MEETING #2 NOTES

Eastern Corridor Segments II and III

US 50 Corridor Focus Area

Figure I-11C

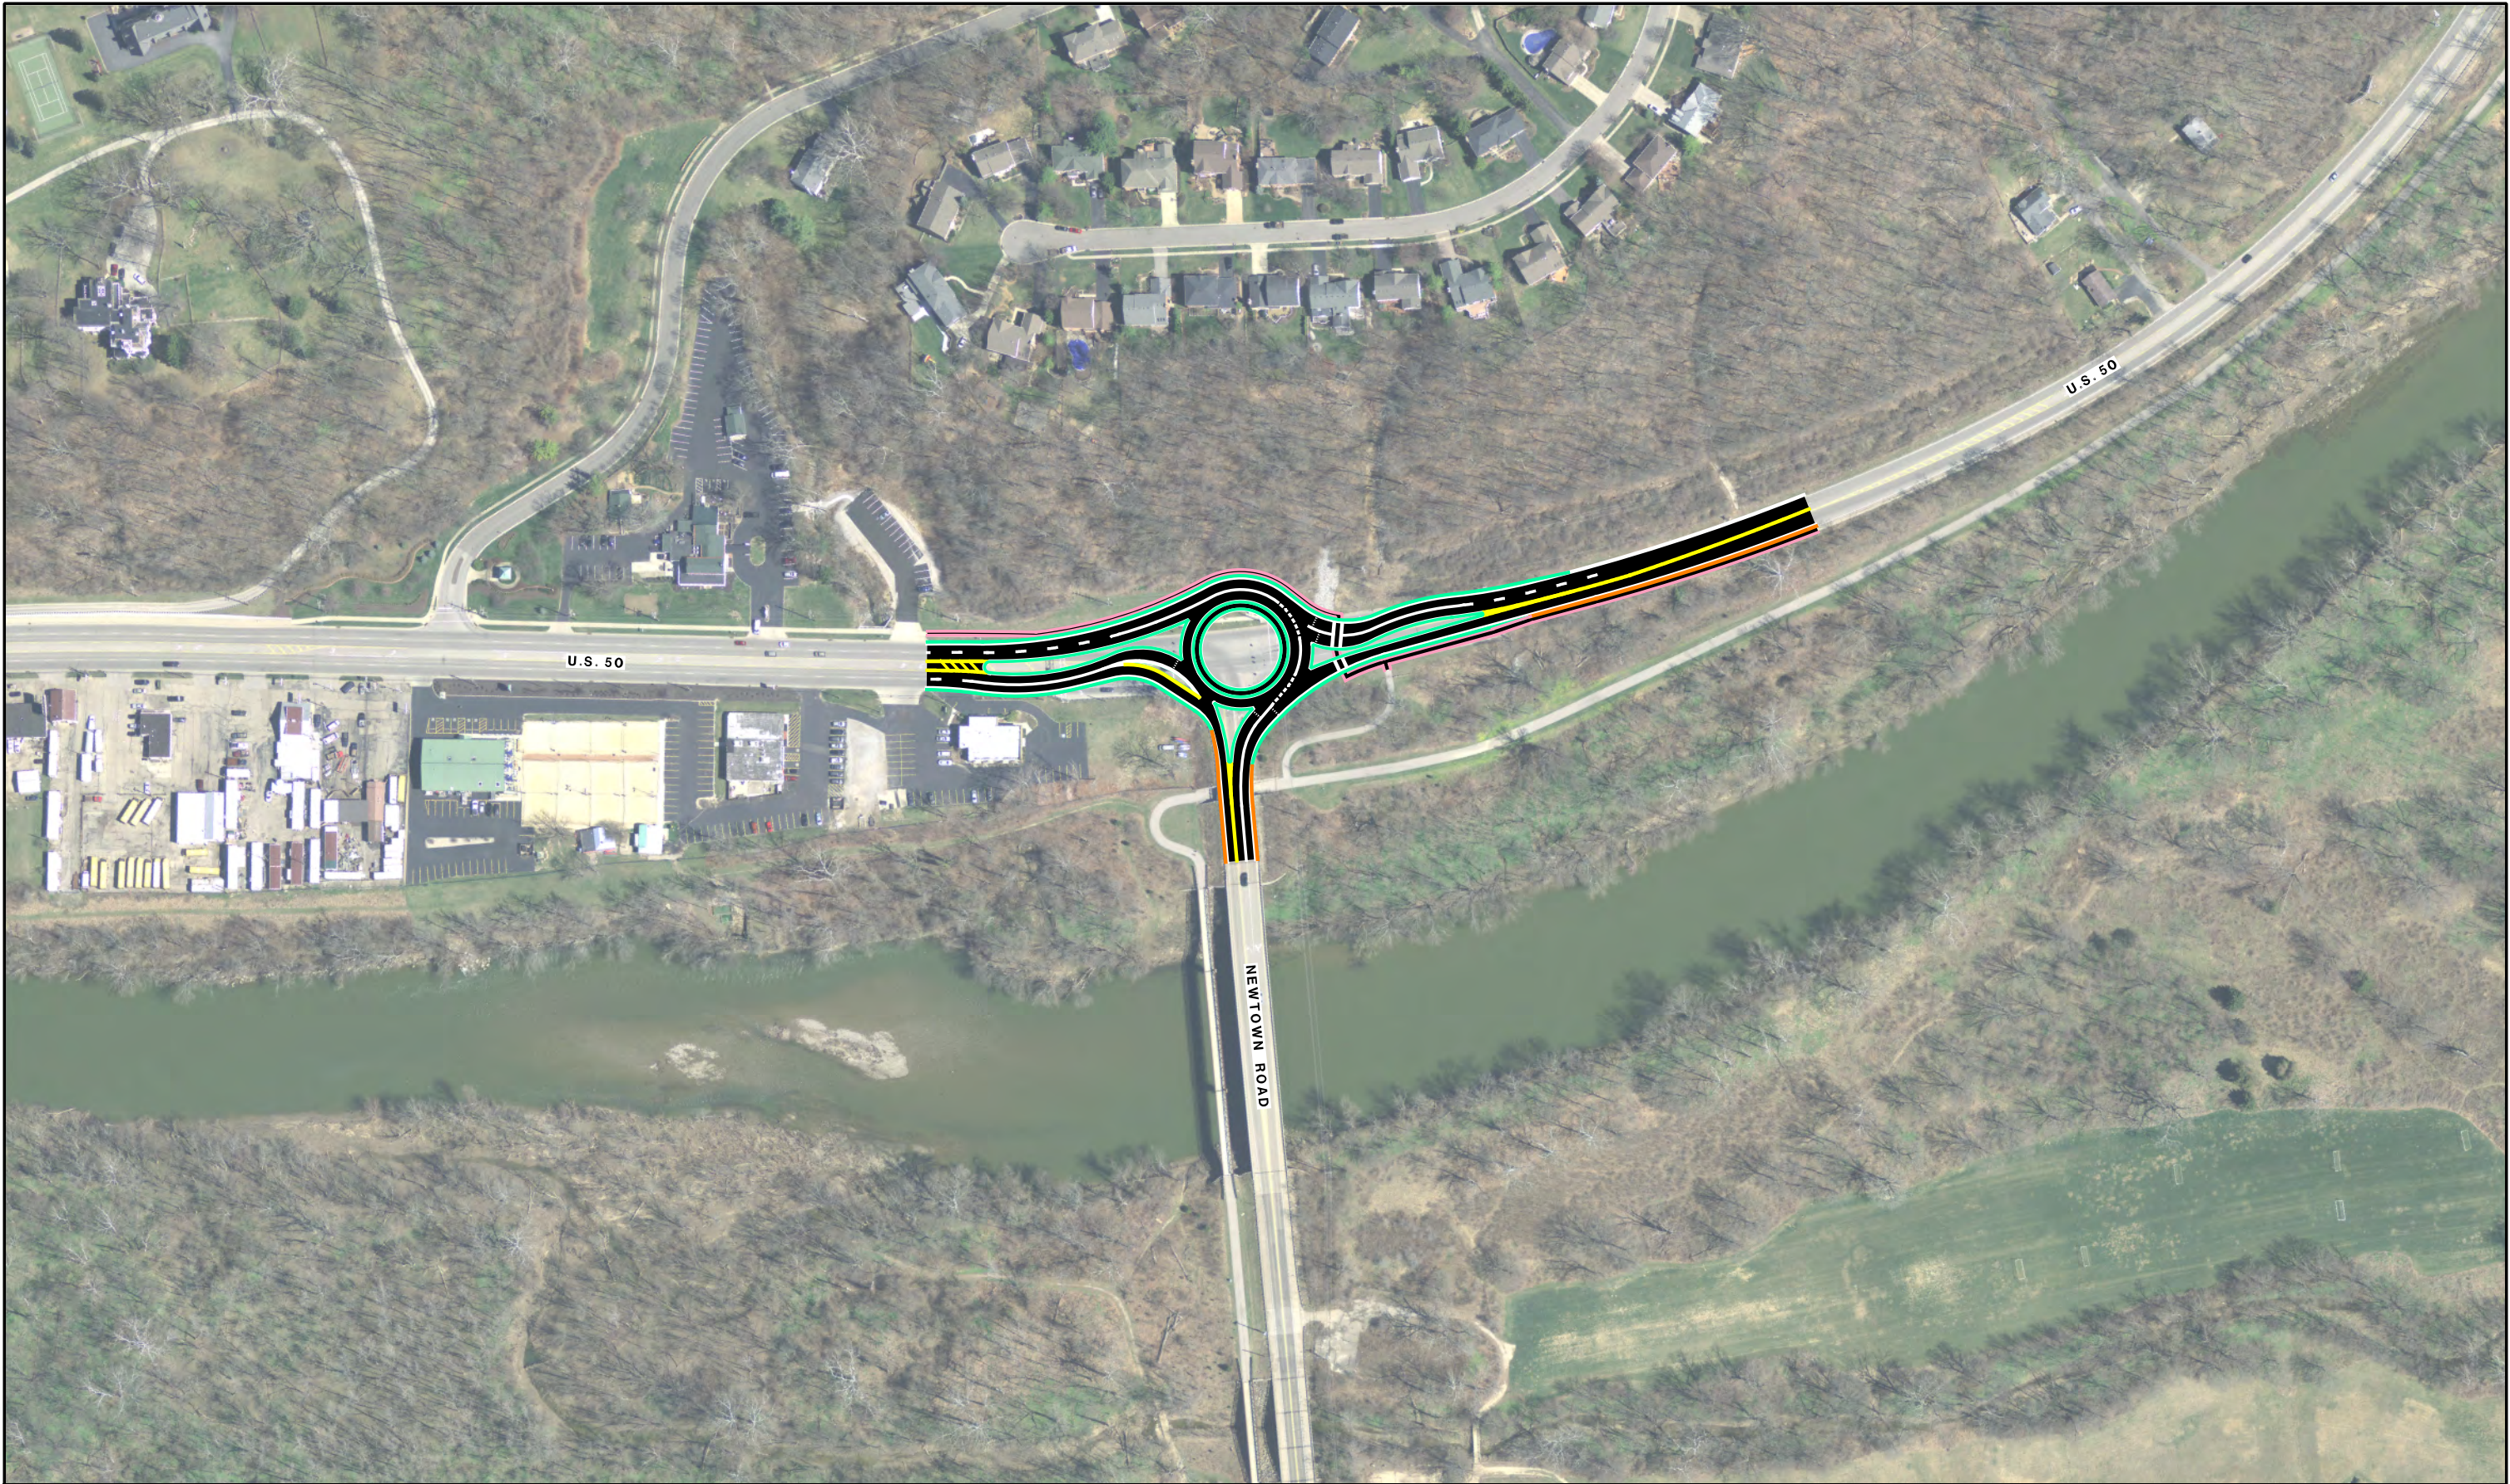
- (Comments are presented as submitted by Committee members; no edits to content were made.)
- Major traffic flow change will require community input. ODOT needs to verify Figure I-11c is drawn to scale and is sized to allow trucks and life-safety equipment adequate clearance/passage through the roundabout.
